# Metropolitan Planning Commission

Part A Deferred Items &  
Zoning Request

April 24, 2008

# **PREVIOUSLY DEFERRED ITEMS**

2007CP-021U-13 Land Use Policies After Amendment

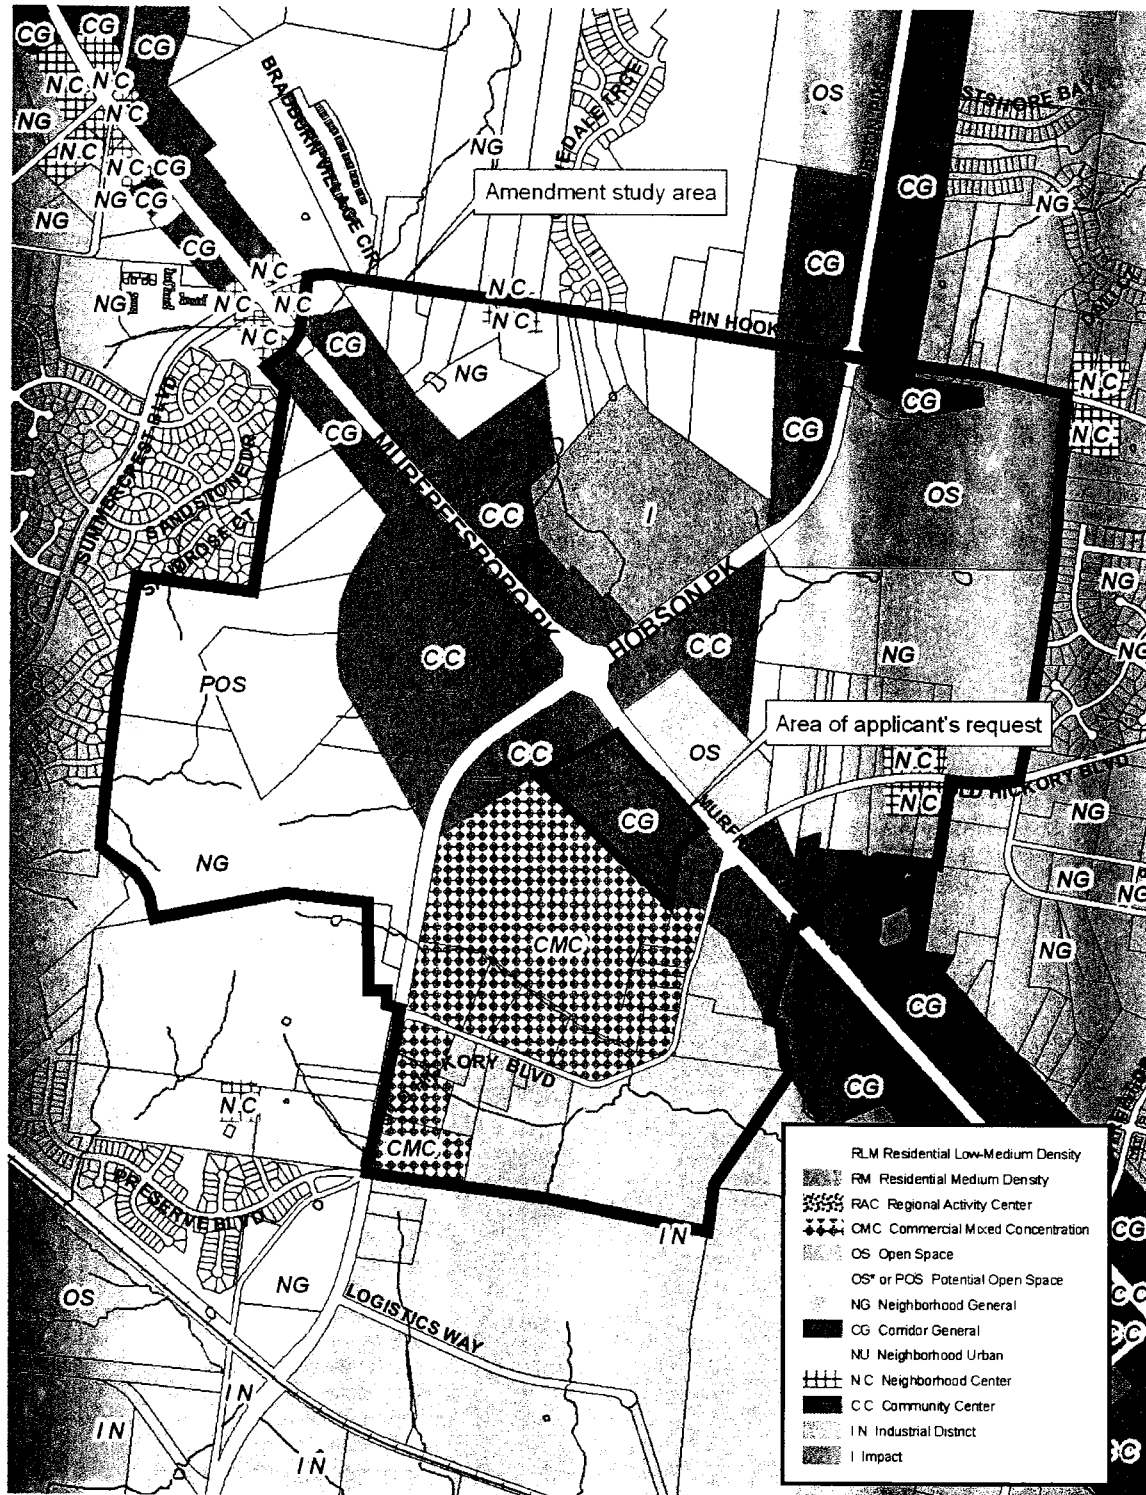
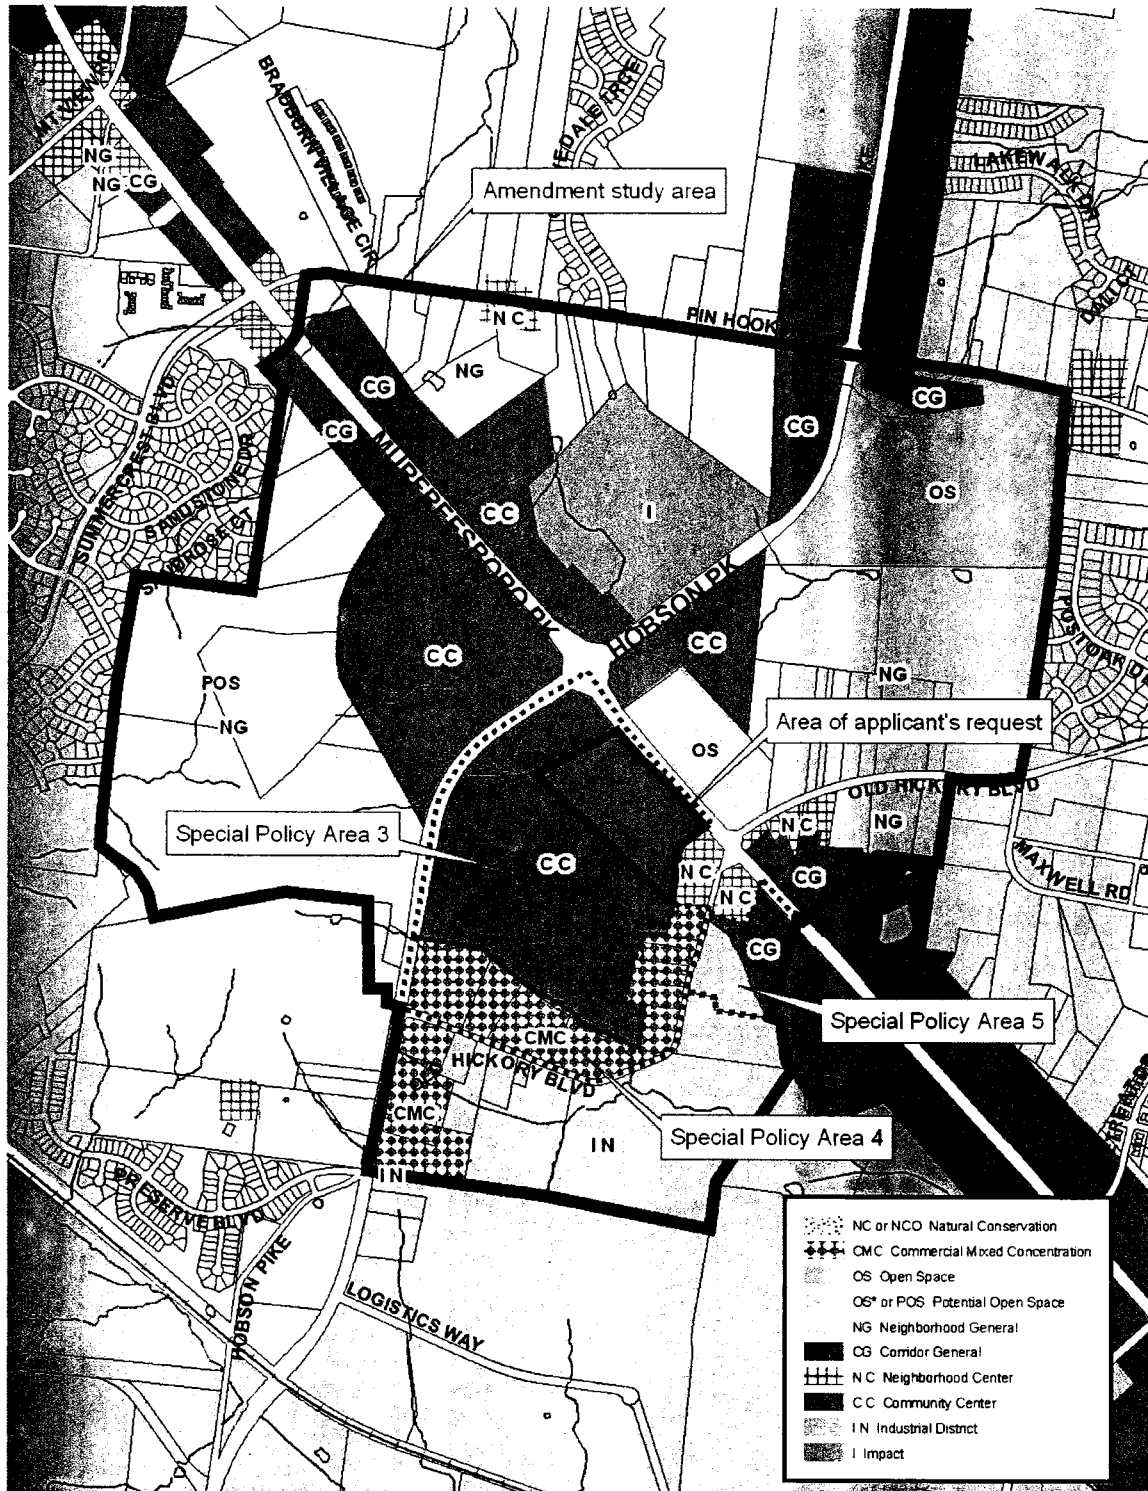
While the mixture of commercial and residential land uses proposed by the applicant for the site is generally appropriate for the location, the requested land use policy is not appropriate. The use of Commercial Mixed Concentration policy would be an expansion of an outdated policy that was put in place primarily to accommodate a special use (Starwood Amphitheater) that is no longer in existence. Now that the use is gone, it is appropriate to reexamine this site in light of its location at a planned community-scaled mixed use intersection that is intended to be developed with high standards of urban design. This is also appropriate in light of the goals of the *Antioch-Priest Lake Community Plan: 2003 Update* regarding Commercial and Residential Development:

Commercial Mixed Concentration policy is appropriate for locations where there is no preference for requiring a mix of use, and/or no preference as to whether the mix of uses within the policy area is balanced and thoughtfully integrated. Commercial Mixed Concentration areas are intended to achieve their development pattern solely through market forces as they arise at the given point in time when each particular CMC area develops. In addition, there is no requirement under CMC policy to use urban design-based zoning tools such as Planned Unit Developments, Urban Design Overlays or the Specific Plan District.

Community Center (C C) policy, on the other hand, is specifically intended to be used for the purpose of developing concentrations of integrated commercial and higher density residential development that serve several neighborhoods. The residential development within C C areas can occur within vertically mixed use buildings or as free-standing residential that often serves as a transition between the commercial and/or mixed use portions of the C C policy area and adjacent neighborhoods. In either case, these residences serve to provide additional market support to the commercial uses within the center and provide local residents with a housing option that enables them convenient access to consumer goods and services.

As an alternative to the applicant's requested amendment; staff recommends that the entire parcel be placed under Community Center policy to integrate the property into the planned mixed-use, community-scaled intersection at Hobson and Murfreesboro Pikes.

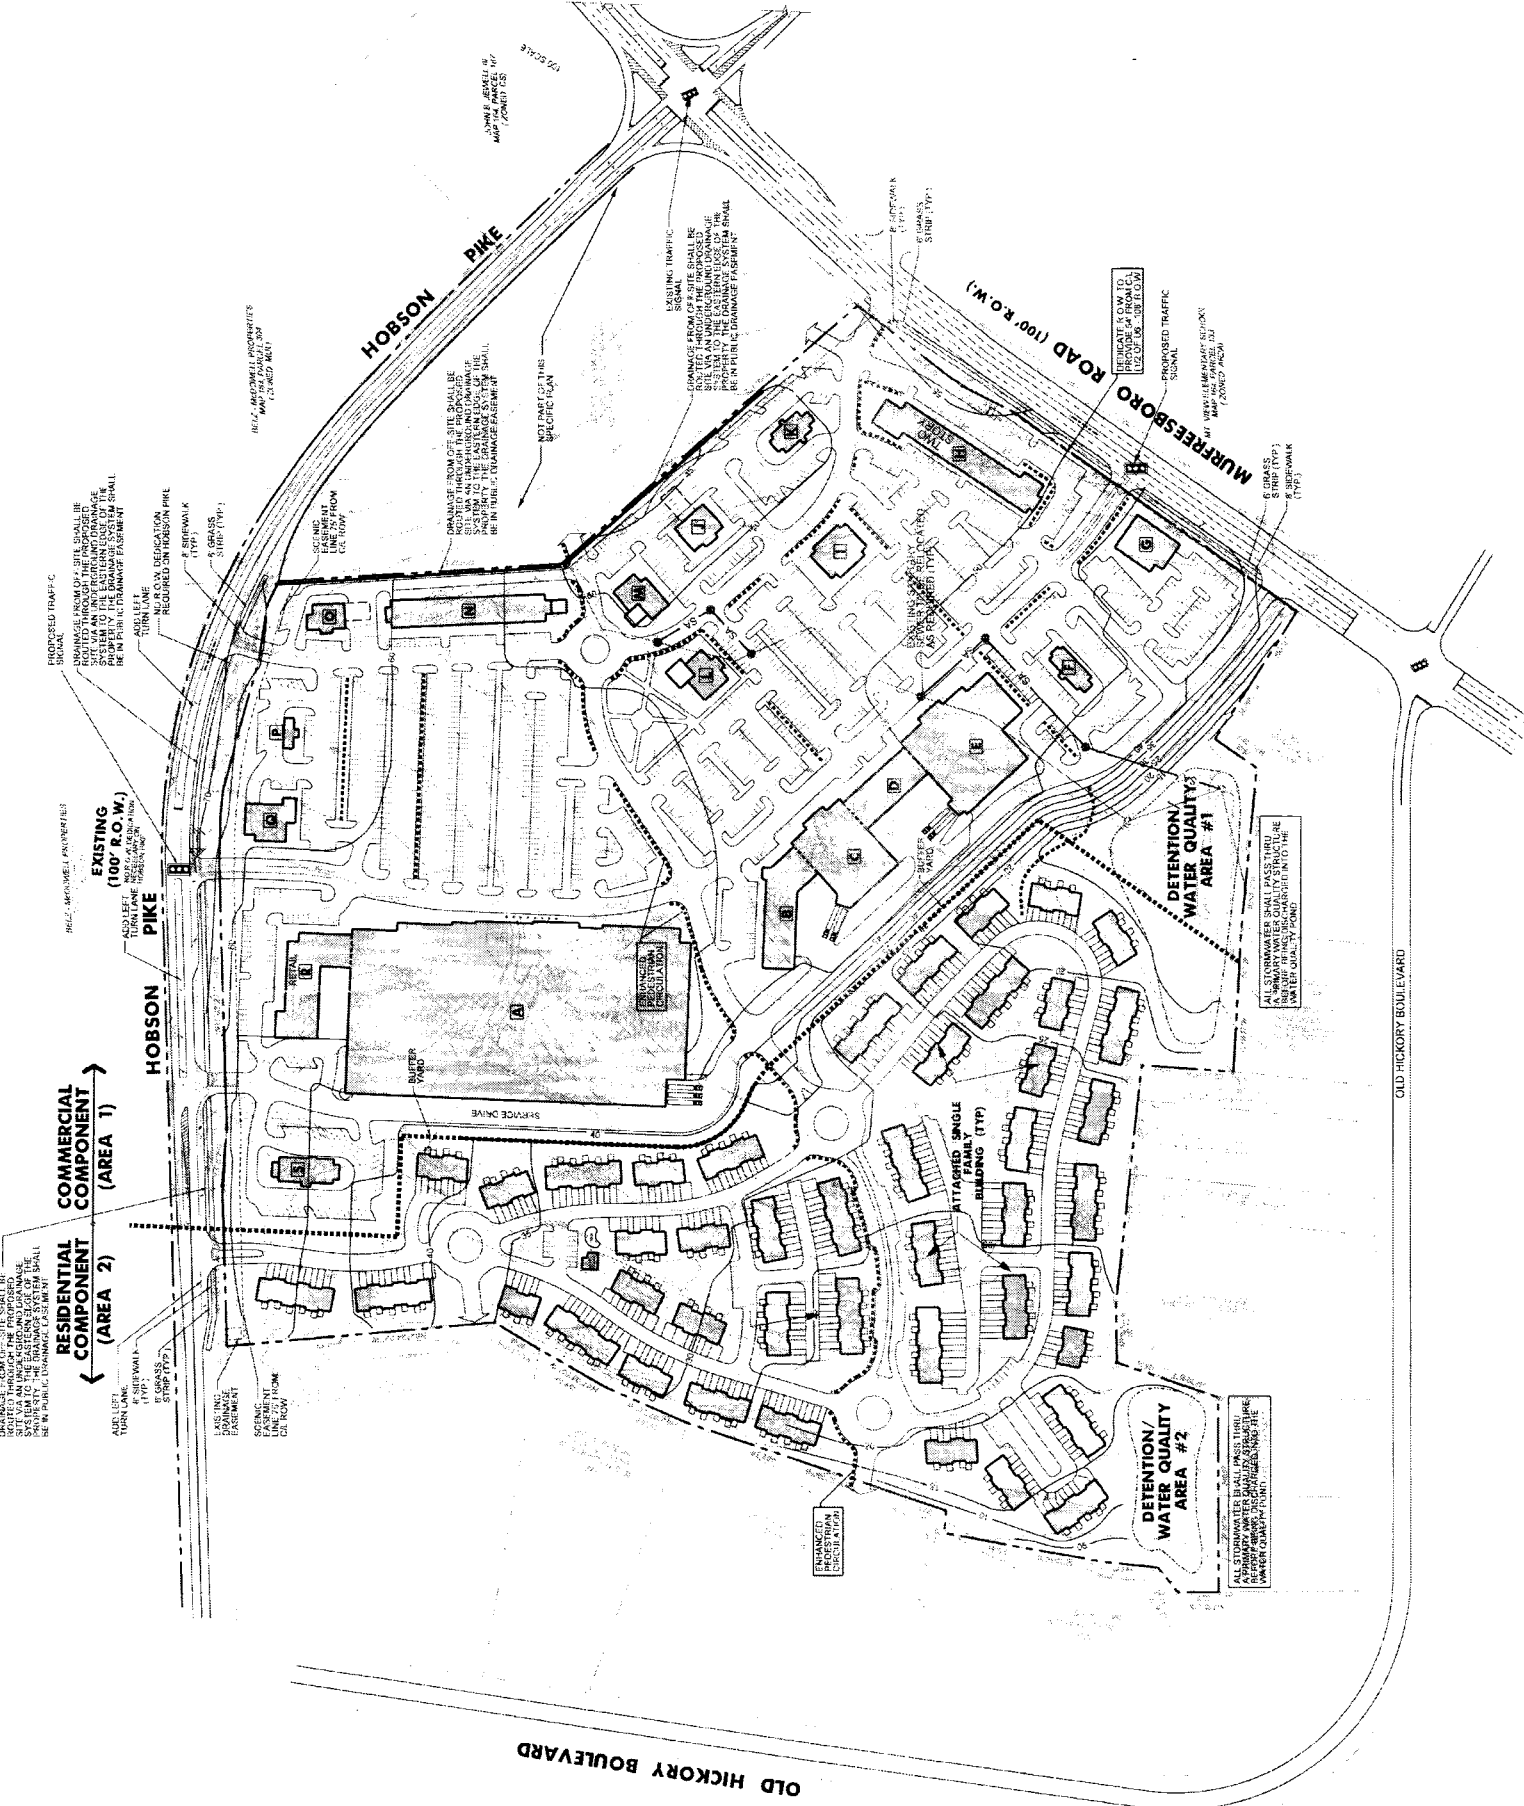
No. The preliminary SP site plan is inconsistent with the existing Corridor General policy, the requested Commercial Mixed Concentration policy, and the Community Center policy recommended by staff.

- The Corridor General (CG) policy has been designated on the portion of the property fronting Murfreesboro Pike. The proposed site plan concentrates office and retail uses along the property’s frontage at Murfreesboro Pike, which are contrary to the residential and civic benefit uses that are appropriate in CG areas.
- As stated in the accompanying community plan amendment, the mixture of commercial and residential land uses proposed by the applicant are generally appropriate for this location, but the arrangement of buildings and form of development does not meet the intent of the Community Center (CC) policy.
- Staff recommends the Community Center (C C) policy as an alternative to the requested Commercial Mixed Concentration. The recommended policies address a development form that emphasizes placement of buildings,

The Council Bill for this request was filed while the plan was under review. There are conflicts among the information provided in the Council Bill, the SP application, and the current site plan.

The commercial square footage outlined in the SP application indicates a commercial floor area ratio of .23 on 42 acres, or a maximum total of 420,790 square feet. The Council Bill includes 421,500 square feet of commercial, but the bill also allows revisions to the overall FAR of up to 0.40 for a maximum of 646,430 square feet of commercial land uses if the plan is changed in the future.

The design standards section of the plan state a maximum floor area ratio of 0.23 for the overall commercial component, but a 0.40 floor area ratio per lot. Assuming the floor area ratio per lot is 0.40, then the ratios as proposed conflict with each other, since the per lot maximum exceeds the overall FAR for the commercial component.

The site is accessible via Hobson Pike and Murfreesboro Pike. Four points of access onto Hobson Pike are shown on the plan. Three access points are planned for Murfreesboro Pike. The illustrative plan suggests the internal street network will consist of private drives in both the residential and commercial portions of the development. Pedestrian access will be accommodated by five-foot sidewalks along Hobson Pike and Murfreesboro Pike, but no sidewalks are identified along the streets internal to the development.

1. Widen Hobson Pike at the intersection of Murfreesboro Road to provide one additional through lane in both the NB and SB direction. The additional lanes shall extend 500 ft north and south of Murfreesboro Road with transitions per AASHTO/MUTCD standards.
2. Widen Hobson Pike at the intersection of Murfreesboro Road to provide one additional left turn lane in both the NB and SB direction and with tapers per AASHTO/MUTCD standards. Each of the northbound left turn lanes shall provide a total of 250 ft of storage. Each of the southbound left turn lanes shall provide a total of 150 ft of storage.

13. Relocate proposed westernmost access drive on Murfreesboro Road along the existing property line and provide a cross access easement to Map 164 Parcel 173.

14. Along Hobson Pike and Murfreesboro Pike, construct a six (6') foot furnishing zone and eight (8') foot sidewalk, consistent with the Strategic Plan for Sidewalks & Bikeways. Sidewalks to be located within right of way.

Staff recommends disapproval of the zone change request to allow the proposed SP-MU zoning district at this location. The proposed layout does not embody the design principles mandated by the existing or recommended land use policies. The site plan has been

#### Site Plan

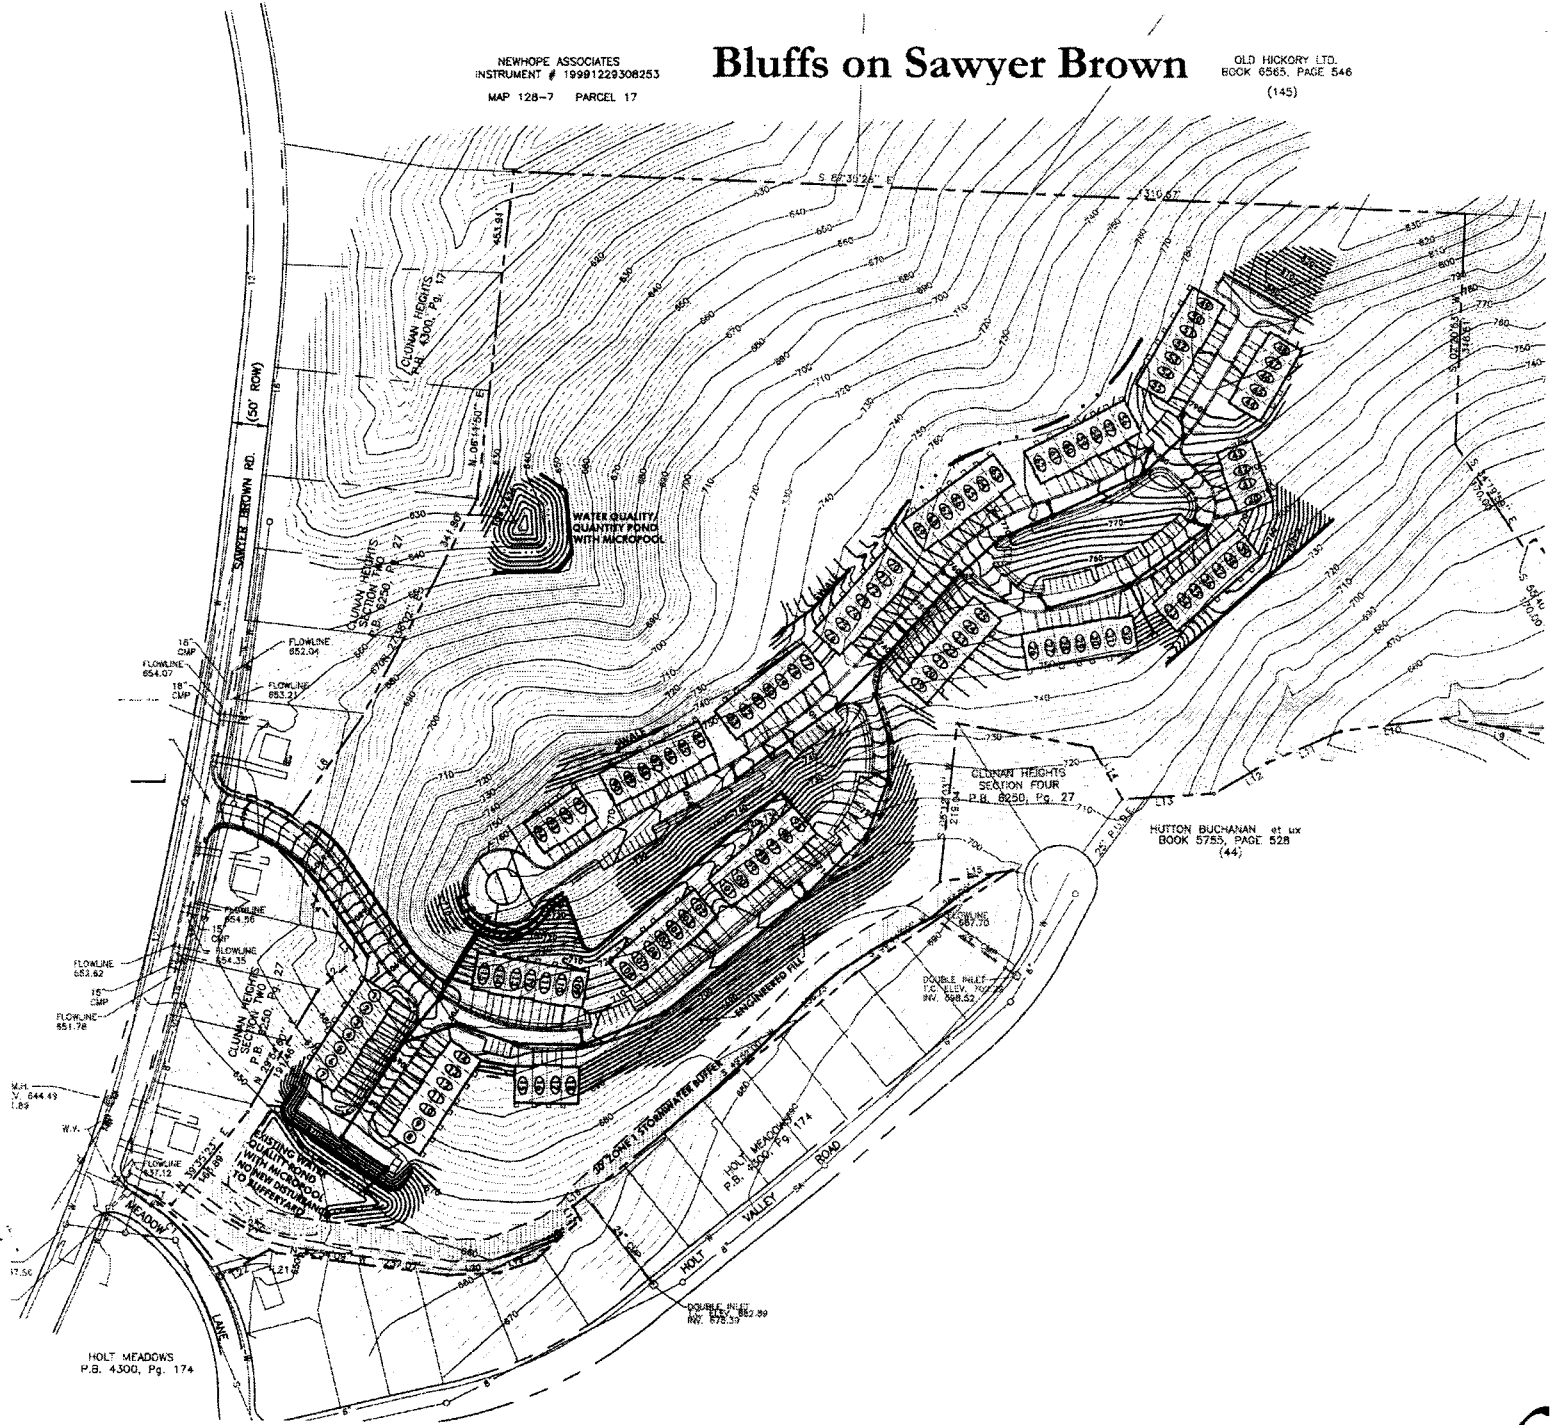
This property contains steep slopes and problem soils. Most of the property has a slope of over 25%. While the development is proposed for the ridgeline, there is grading proposed on some of the steep slopes. Almost all of the grading for the proposed development is within problem soils. This property contains both Bodine-Sulfura, which is prone to movement, and Dellrose Cherty Silt Loam, which is weak, has a lot of fine pores and is quite crumbly.

The applicant has moved the grading away from the homes on Holt Valley Road. The applicant has also added several notes to the plans that address the environmental concerns:

1. A preliminary geotechnical analysis has been performed to insure the feasibility of this proposal. This plan has been modified to indicate placement of roadways and buildings with grading to stable soils and placement of engineered fill. Prior to any construction, a detailed geotechnical report will be submitted with final SP plans.
2. Prior to the issuance of Use and Occupancy permits, a certification letter stamped by a licensed engineer stating that everything has been constructed in compliance with the geotechnical report shall be submitted.

1. There shall be no construction access from Holt Valley Road.
2. Remove dumpster from open space and place in a less visible area.
3. This SP is limited to multi-family residential.
4. For any development standards, regulations and requirements not specifically shown on the SP plan and/or included as a condition of Commission or Council approval, the property shall be subject to the standards, regulations and requirements of the RM4 zoning district as of the date of the applicable request or application.
5. A corrected copy of the preliminary SP plan incorporating the conditions of approval by the Planning Commission and Council shall be
